Subject: Zion Station Units 1 and 2
I.E. Bulletin 80-11, Masonry Walls
NRC Docket Nos. 50-295 and 50-304

ATTACHMENT

RESPONSE TO REQUEST FOR ADDITIONAL INFORMATION
ON
MASONRY WALLS

WALL A-579-9 NORTH ELEV.
 SCALE: 1/4" = 1'-0"

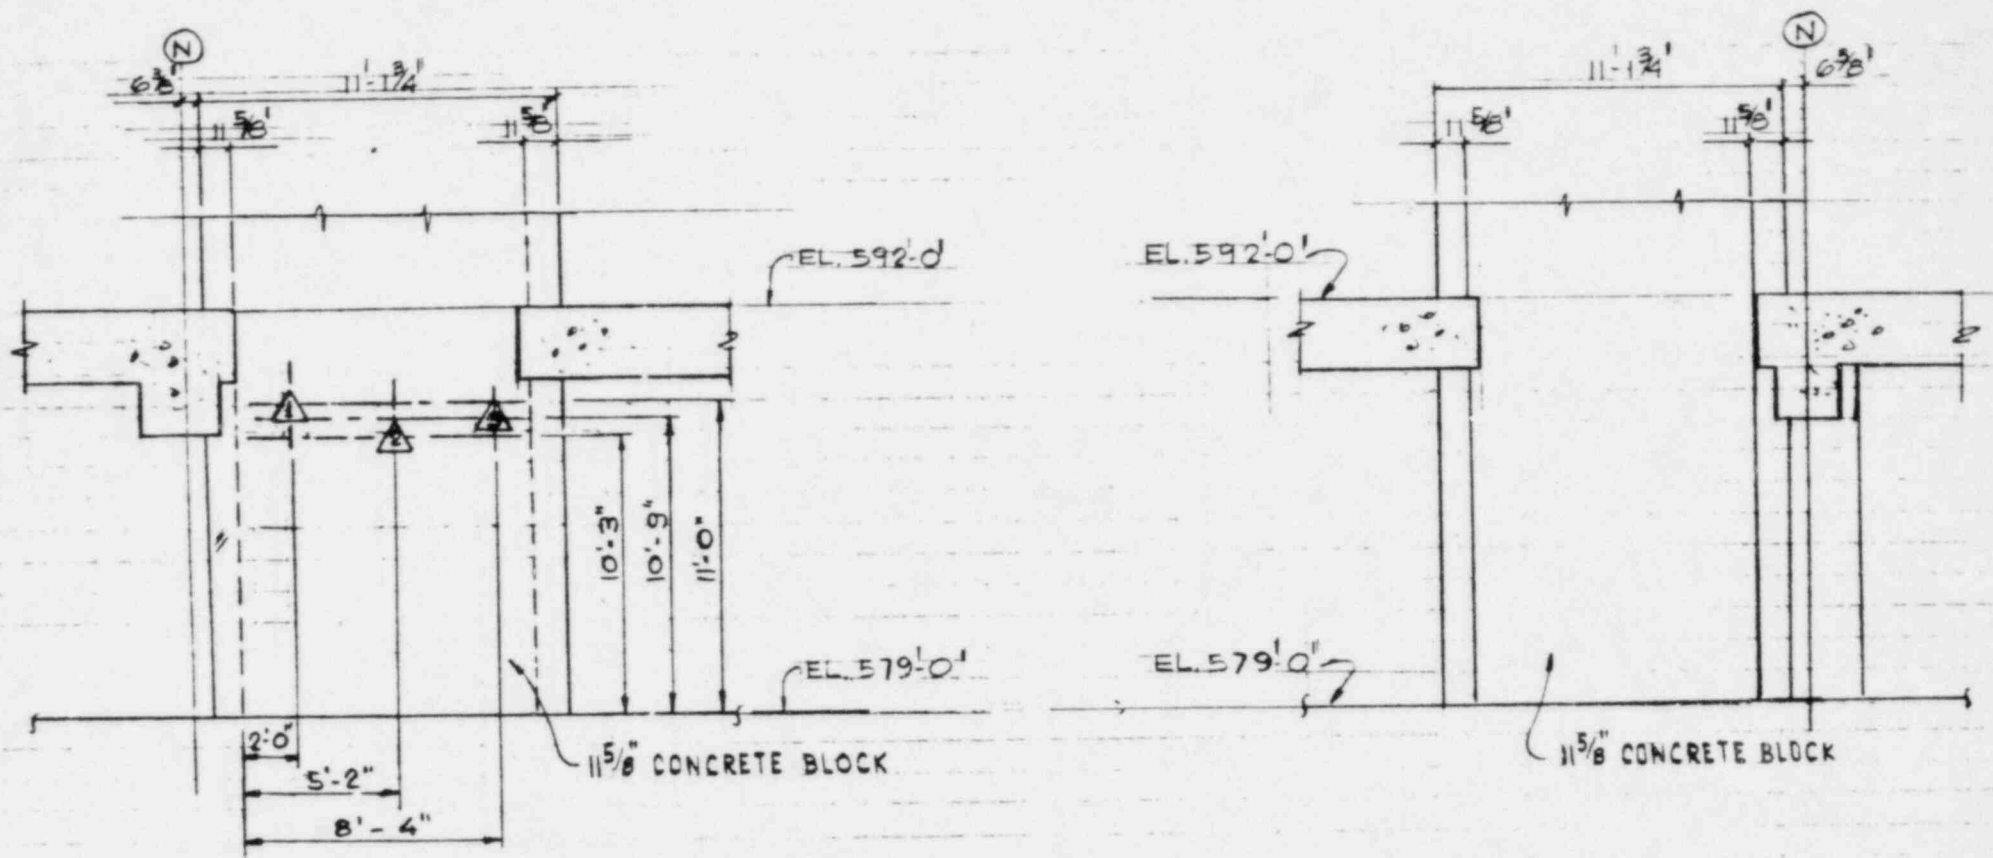
4. Provide the number of unreinforced walls and a sample calculation illustrating the analytical approach used for single-wythe and multiple-wythe wall.

7. Indicate the mode of failure of each wall not qualified under the working condition. Provide details of proposed modifications for each wall with sketches and demonstrate through sample calculations that the wall will be qualified after modification.

There are a total of 130 safety-related walls at Zion, 100 of which are single-wythe construction. Of these, 86 walls are unreinforced. A sample calculation illustrating the analytical approach is attached for your reference.

The information regarding walls originally found to be not qualified is on file with our Architect Engineers and is available for your review at their offices. A sample calculation has been included in response to Question Number 4.
